Technical Memorandum

Date: June 11th, 2010
To: Brian Beyak, P.Eng, Manitoba Hydro
From: Jamie Ellis, P.Eng, AECOM
Project Number: 0217-200-07 (3) [Hydro Ref: 243 981 0100]
Subject: **Keeyask Infrastructure Project – North Access Road Start Up Camp
Design for Wastewater Disposal
Additional Information at June 11th, 2010**

Drain Field Distribution Plan

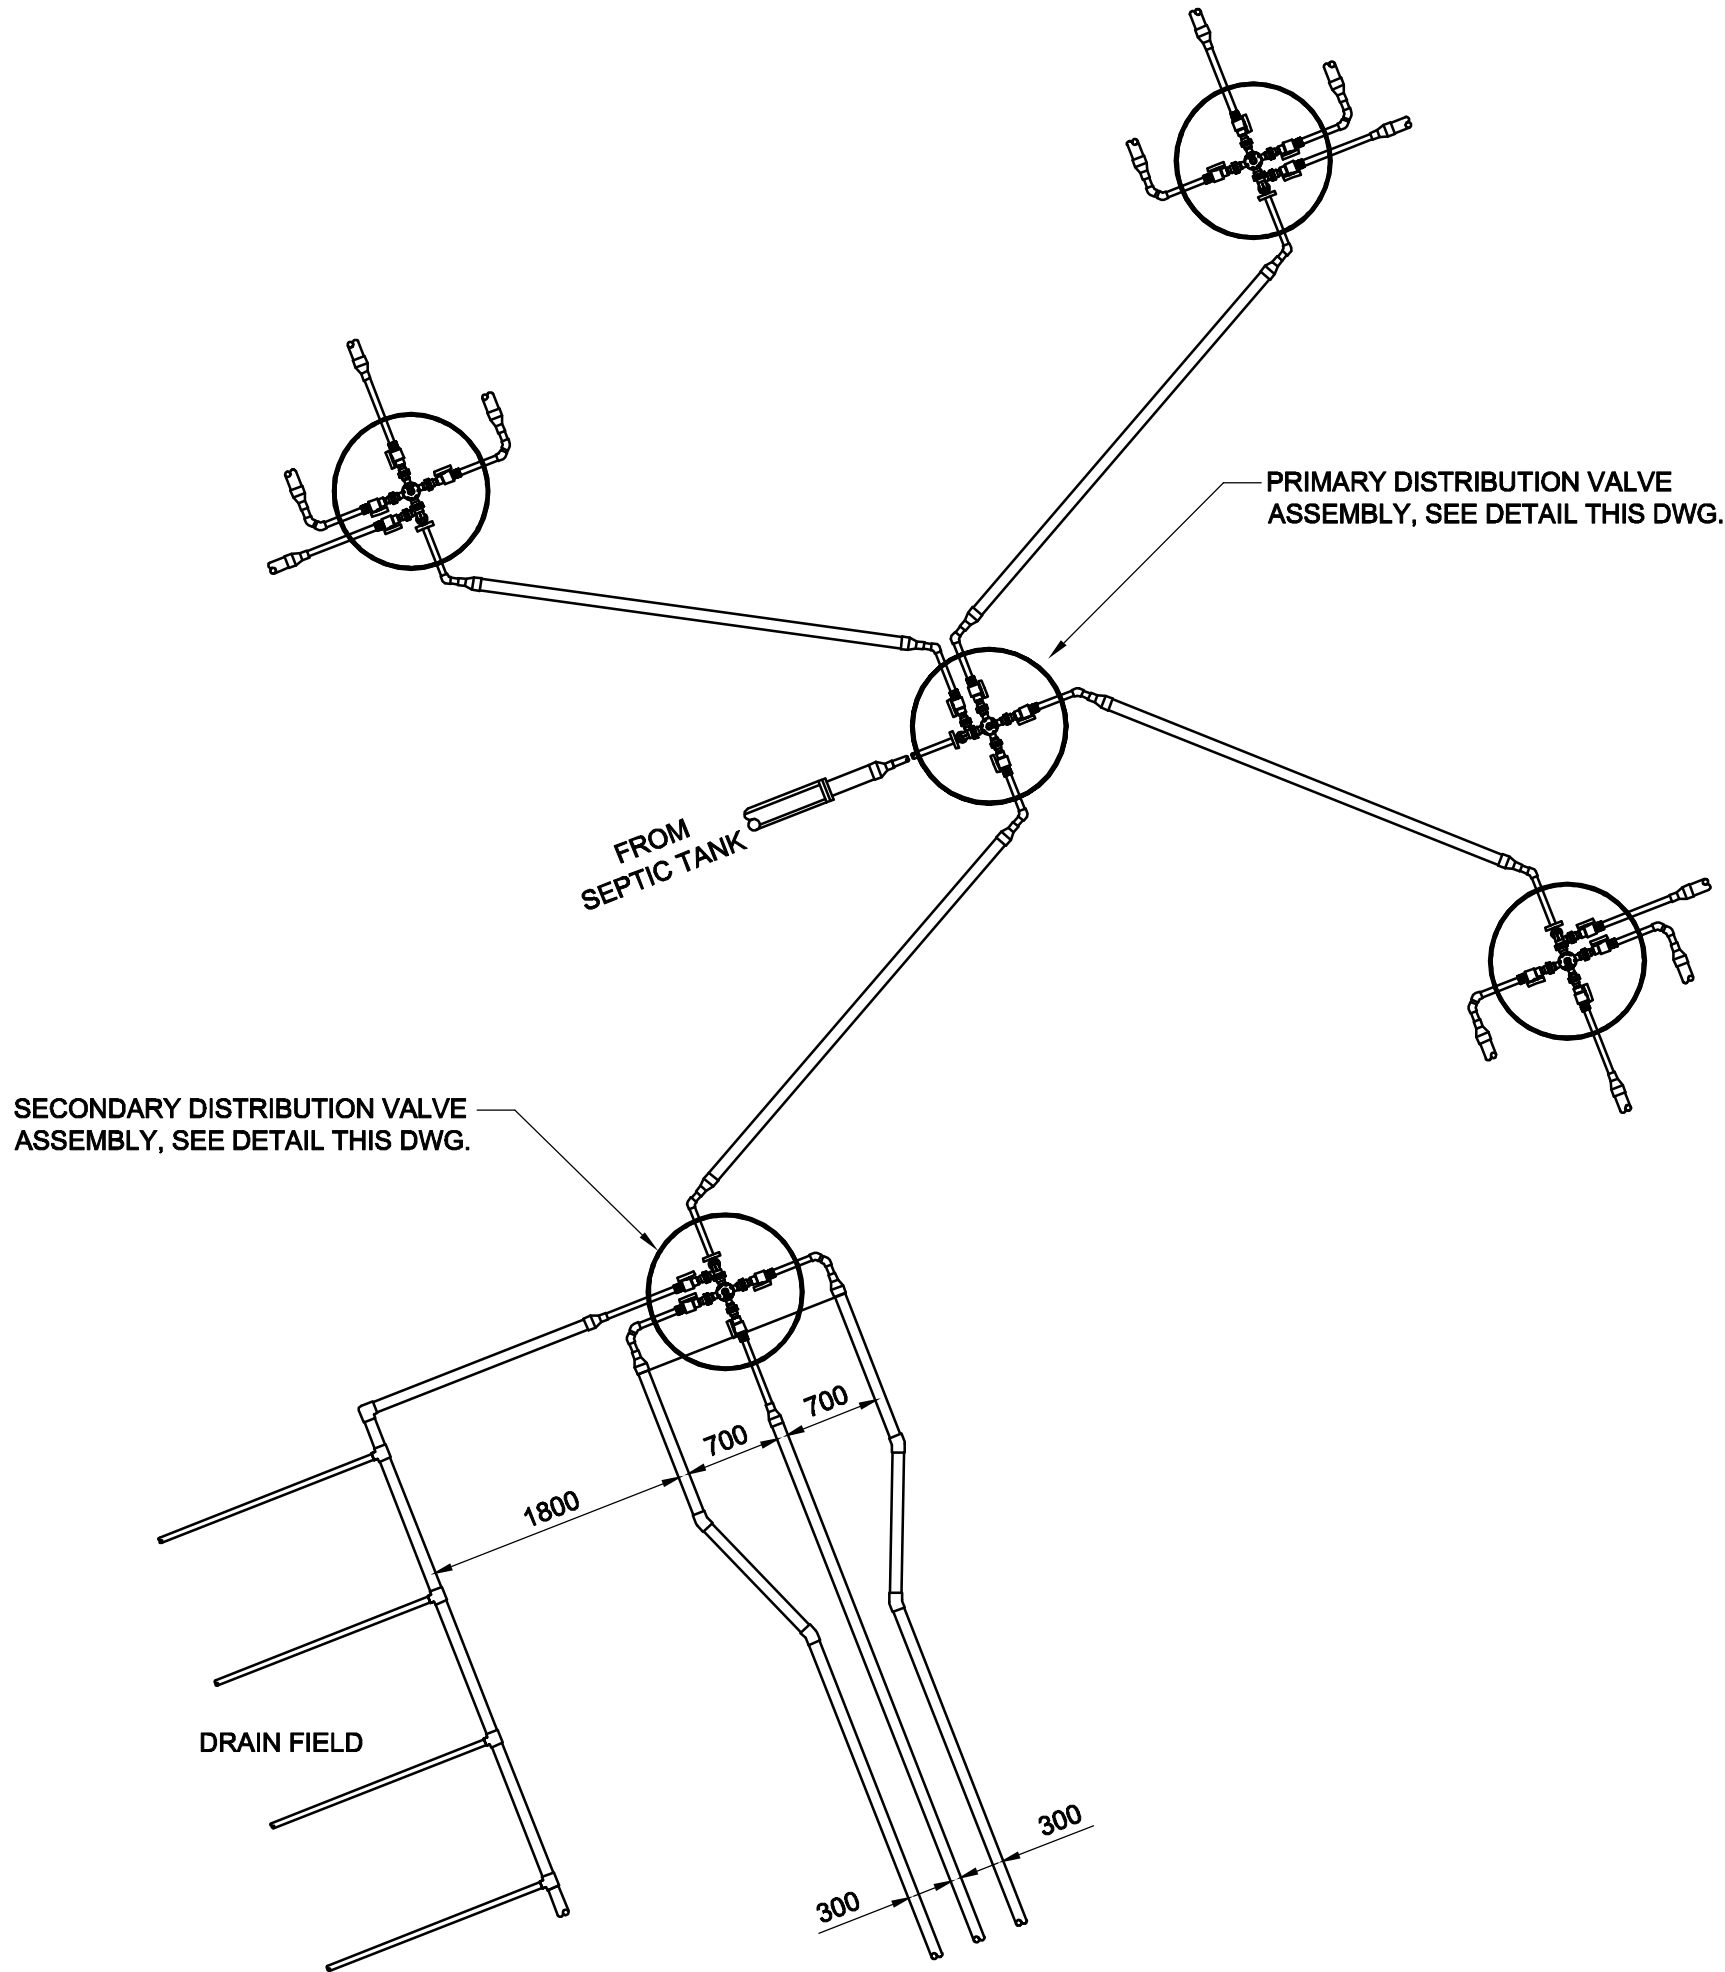
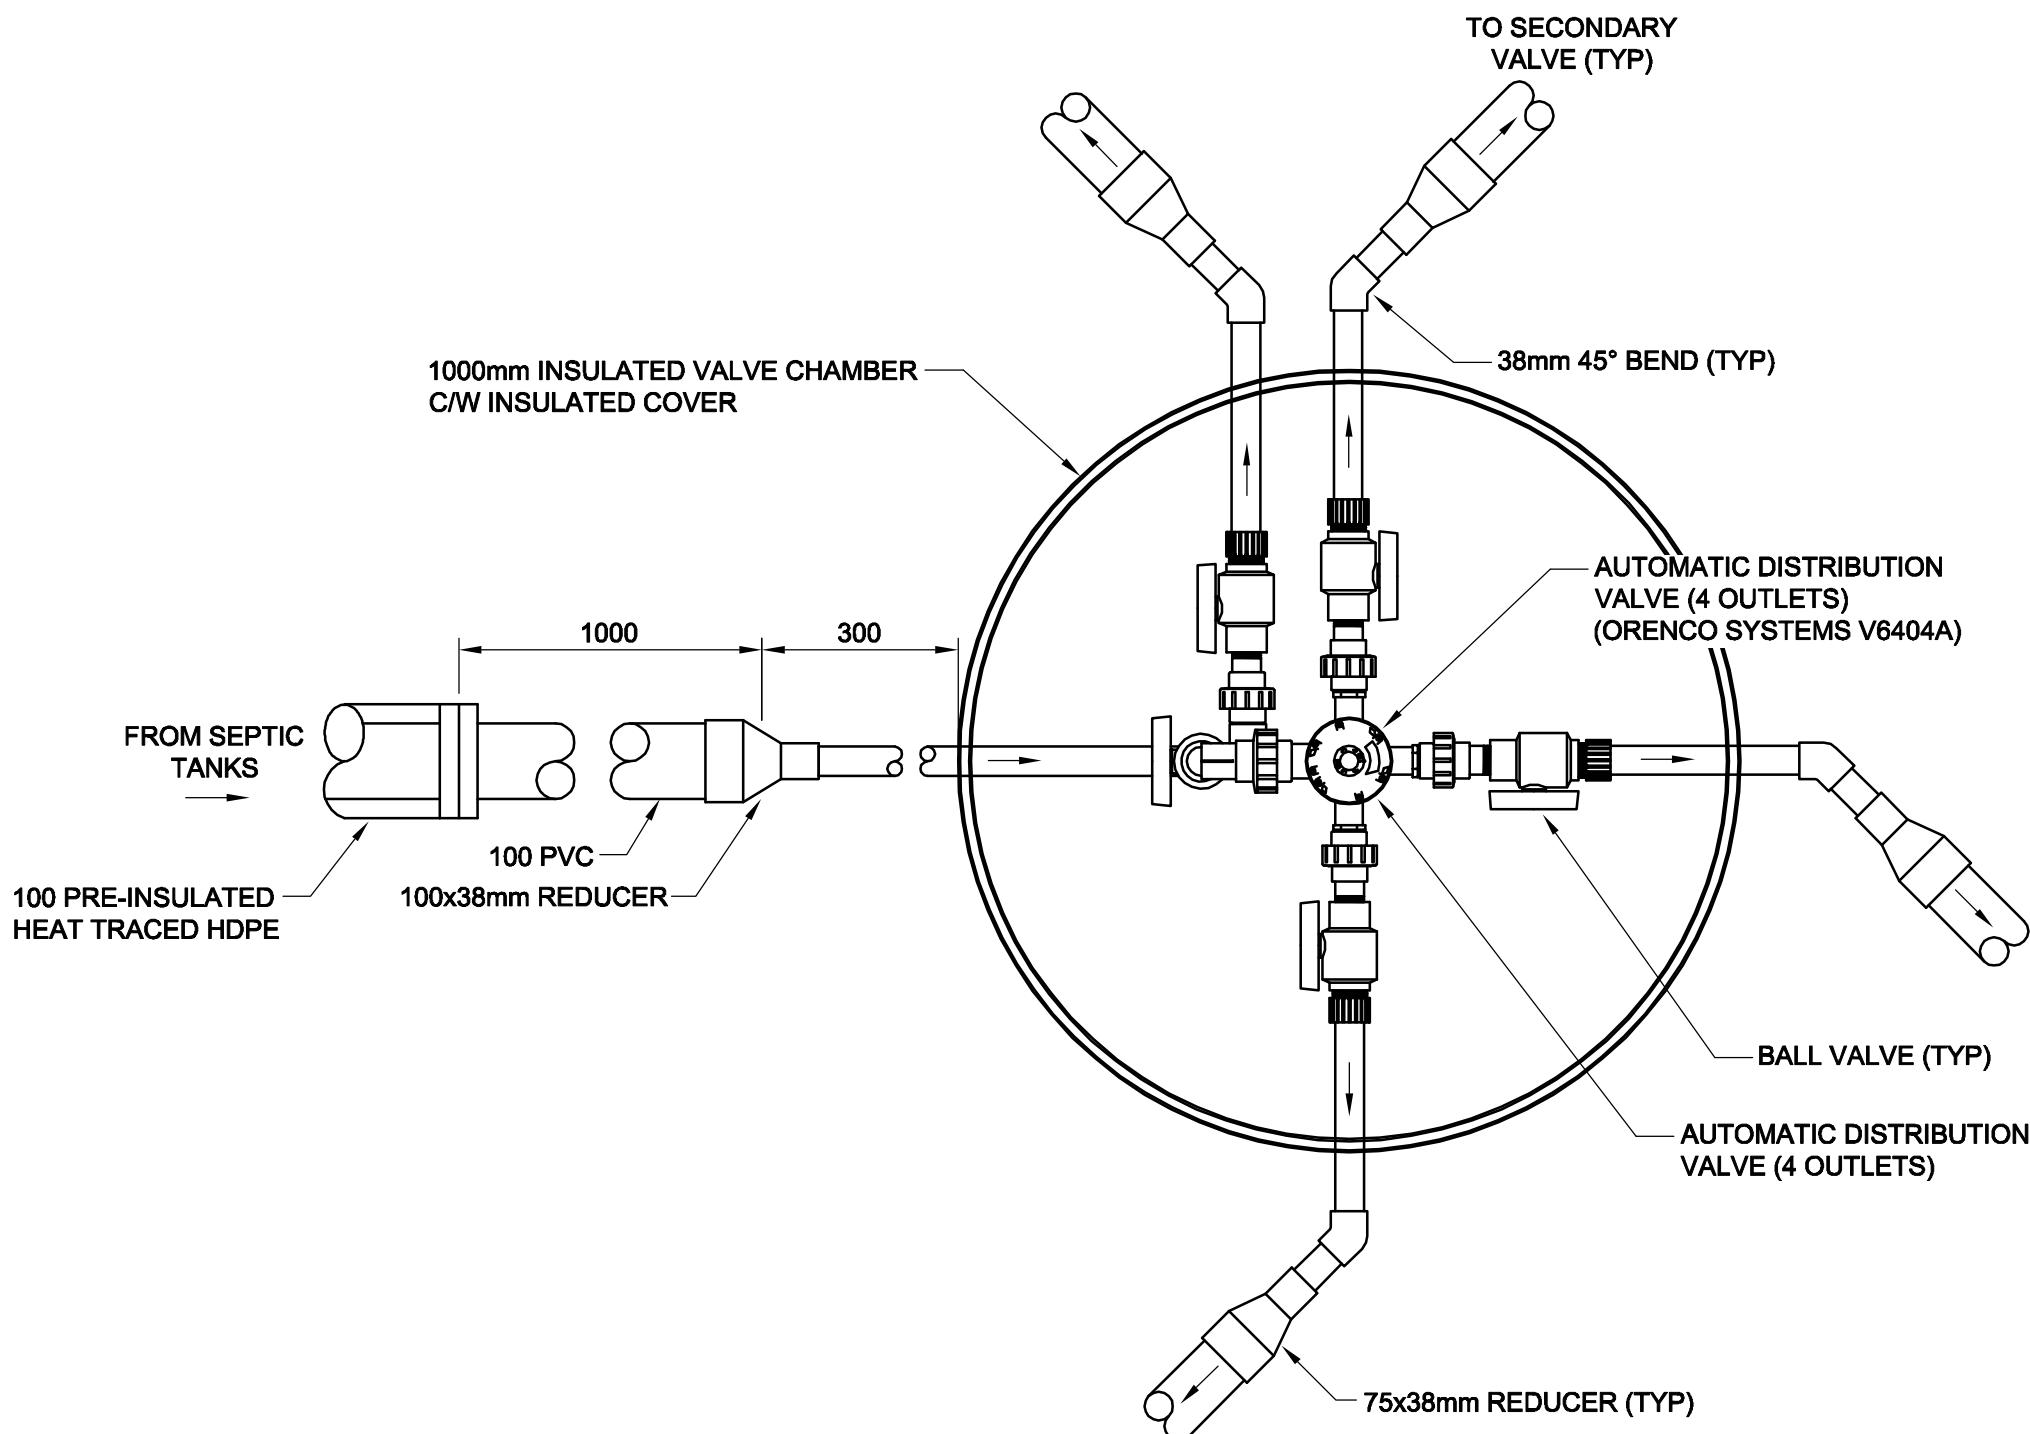
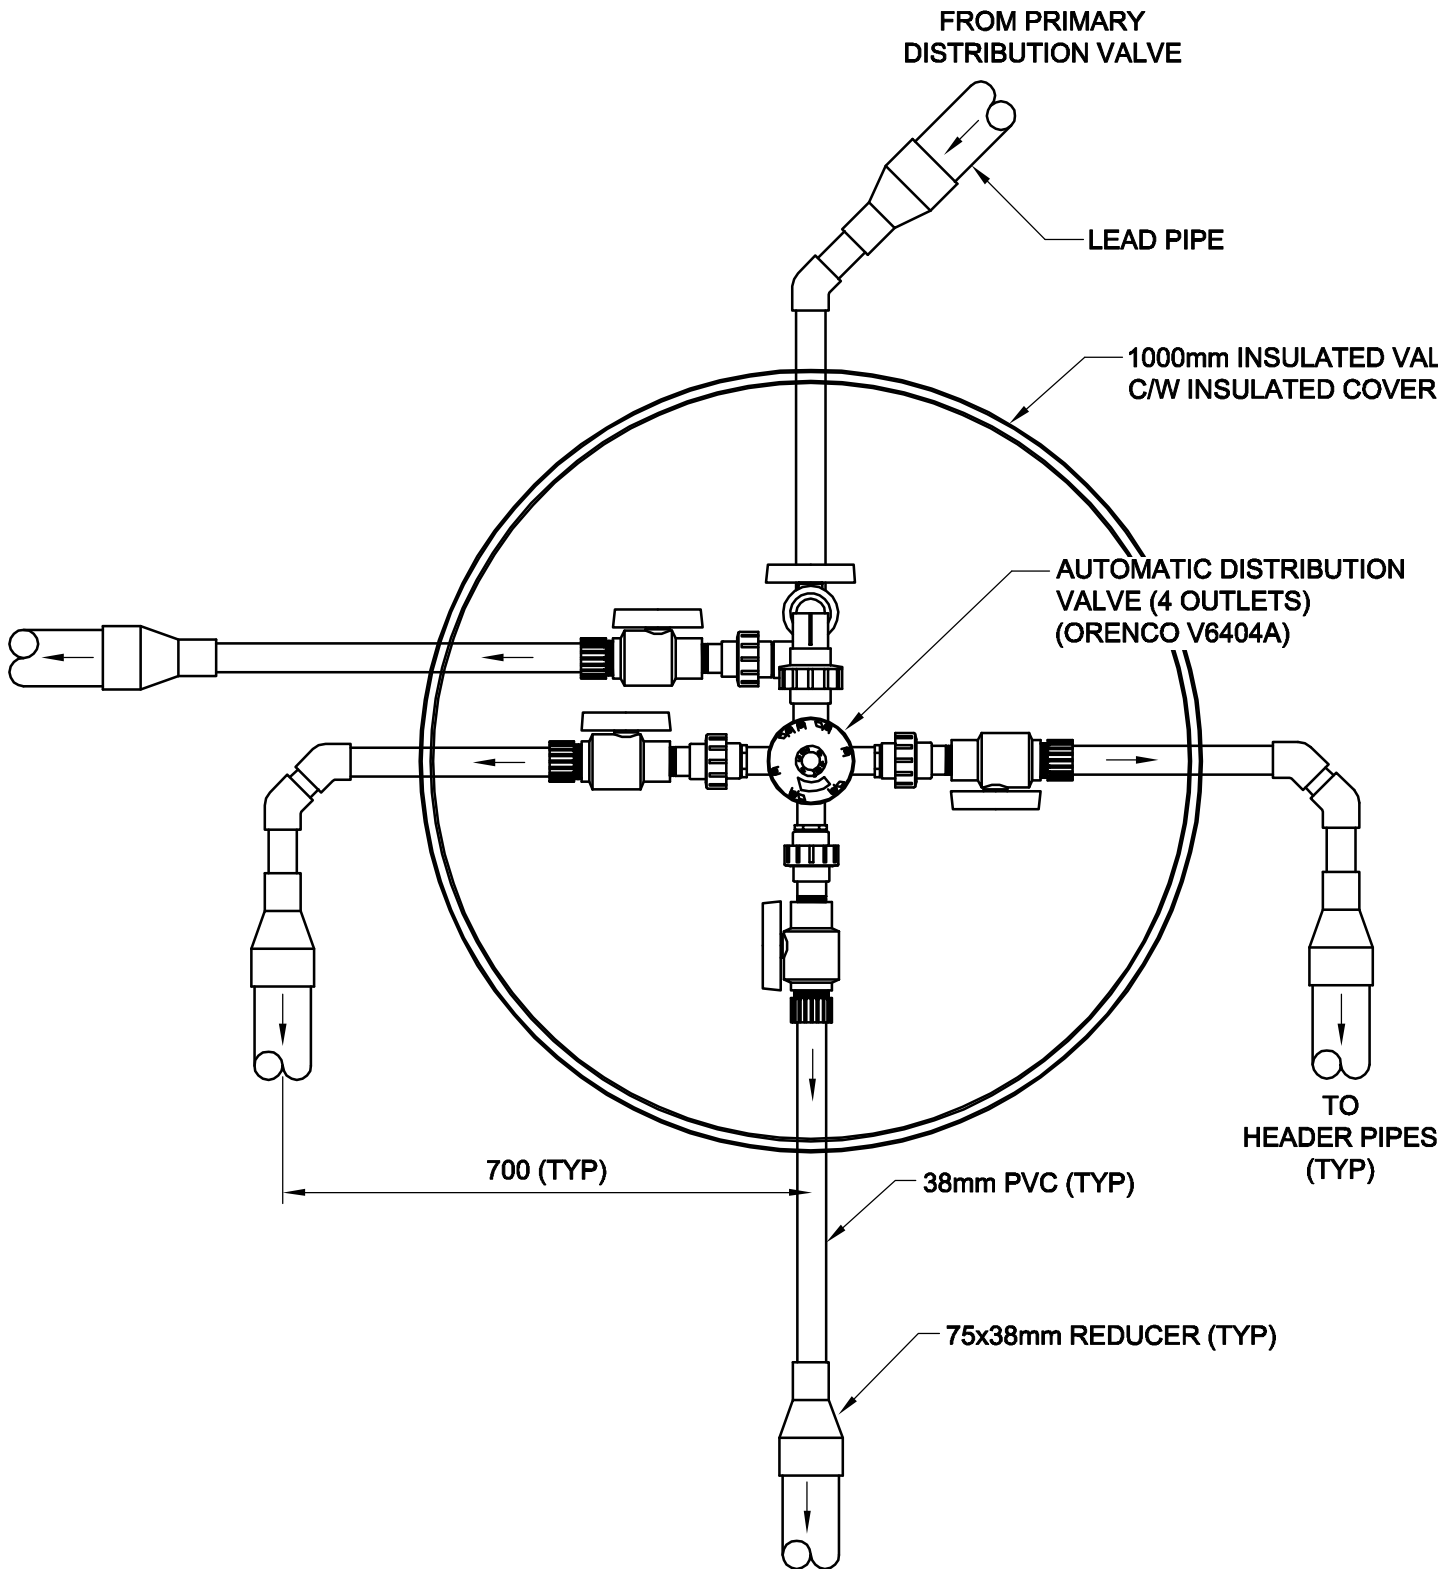
As shown on the drawings, it is proposed that an arrangement of 5 automatic distributing valve assemblies (1 primary and 4 secondary, each mechanically operated) which operate with each pump cycle. As such, flow is sequentially directed to a total of 16 zones across the 4 cells.
